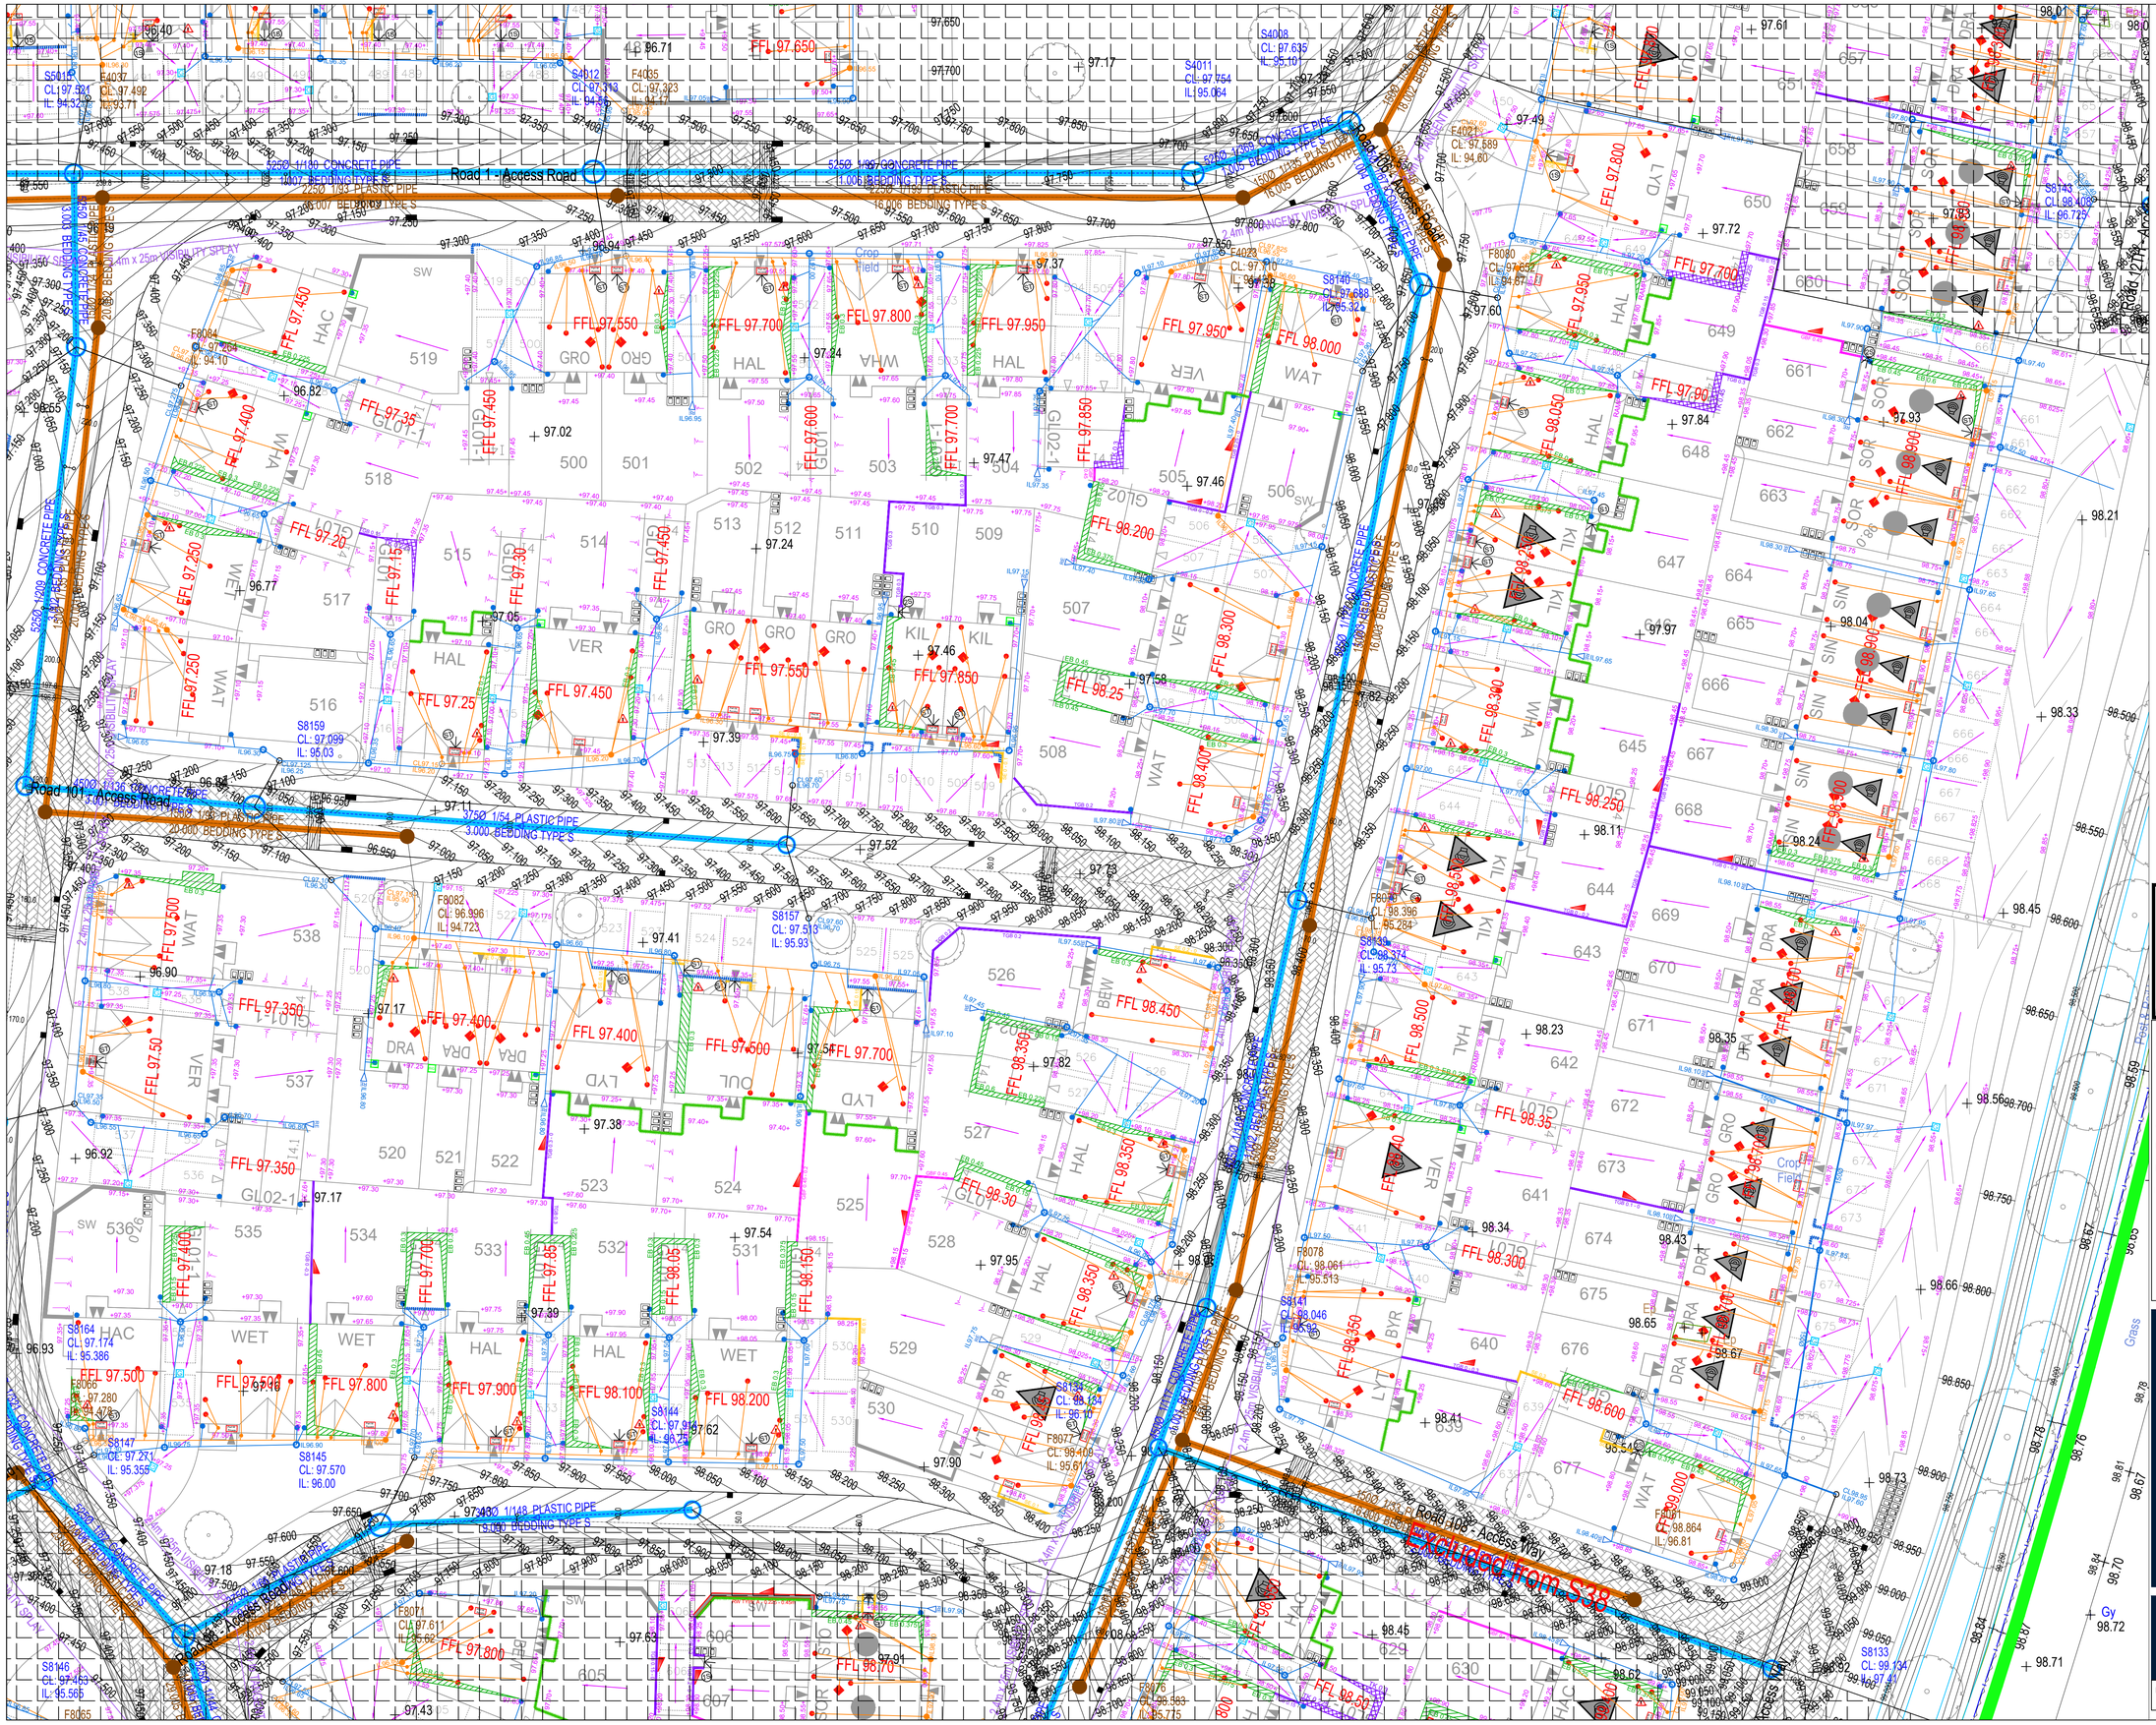
A	Updated to the latest layout. Private drainage added. Garden drains clarified.	17.04.24	DS
B	Aco drain in key amended to 'channel drain'. Garages 540, 541, 558-560, 564-566, 628, 641, 645, 648, 649 & 653 have tanking removed or reduced. EB added to garages 677, 539 & 540. Various TGB added to allow for tanking removal.	31.05.24	DS
C	POS path levels added. Topsoil mounds also added.	10.06.24	DS
D	Gullies in corners replaced with ACOs where possible.	11.07.24	DS
E	Plot 524 moved forward slightly. Externals updated accordingly.	06.12.24	DS
F	Updates to FFLs following LLFA comments	03.01.25	DS
